# Access Compliance Report

## Public Rights-of-Way

### (Curb Ramps)

| Intersection ID: 48955 | Main Street: ROYA_PL | Cross Street: DAVID_JENNINGS_AV | Location: S            |

| ADA ID: 187241048C94   | Ramp Type: Perp      | Initial Pass/Fail: Fail         | Overall Compliance: No |

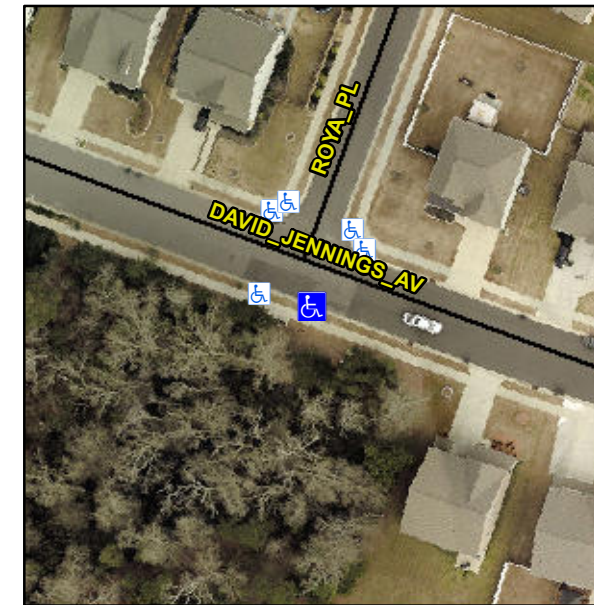
**Not Found, R304.5.1**

| Compliance | Description           | Data  | Compliance | Description                 | Data |
|------------|-----------------------|-------|------------|-----------------------------|------|
| No         | Ramp Width (in)       | 47.0  | Yes        | Ramp XSlope (%)             | 1.8  |

**Remove & Replace Entire Ramp.**
